IMPROVED BANDED BELT FOR HYDRO DRIVE.

Models:
IS1500Z SERIES, AND IS2000Z SERIES

Work Performed: Repaired per Service Bulletin F083

Cross-Section View of New Banded Belt

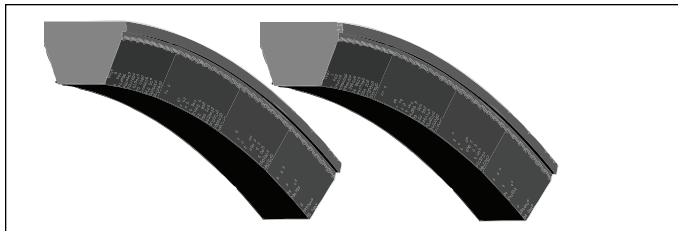
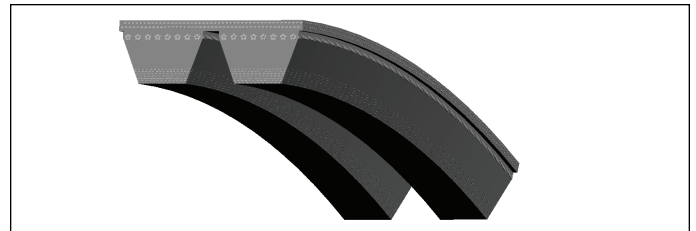
An improved banded belt (part# 5100555) has been developed to replace (part# 22314) on IS1500Z and IS2000Z units only. If a field failure occurs the new (5100555) banded belt should be used for the replacement.

IDLER ARM SHOULD BE CHECKED FOR FREE MOVEMENT, AS THIS IS THE #1 CAUSE FOR BELT FAILURE.

Figure 1. Hydraulic Pump Drive Belt Replacement

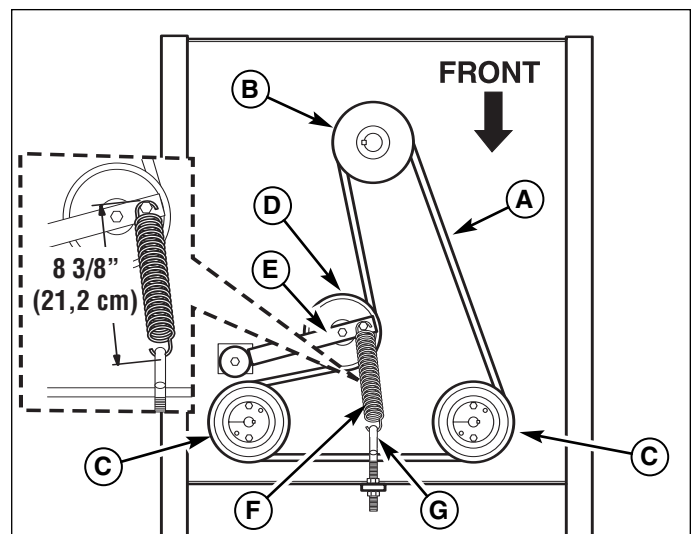
2. Remove the PTO drive belt.
3. Remove the hardware that secures the clutch anchor pad to the PTO clutch.
4. Loosen the nut towards the front of the machine on the spring anchor hook (G, Figure 1) to release the majority of the belt tension. Use caution and remove the nut to completely release the tension.

5. Remove the old belts and replace with the new banded belt. Make sure the V-side of the belt runs in the grooves of the crankshaft pulley and pump pulleys (B & C).

6. Reinstall the anchor hook (G) into the anchor tab and loosely fasten the nut. Adjust the anchor hook until a measurement of 8-3/8" (21,2 cm) is achieved from the outside of the spring hooks. Tighten nut.
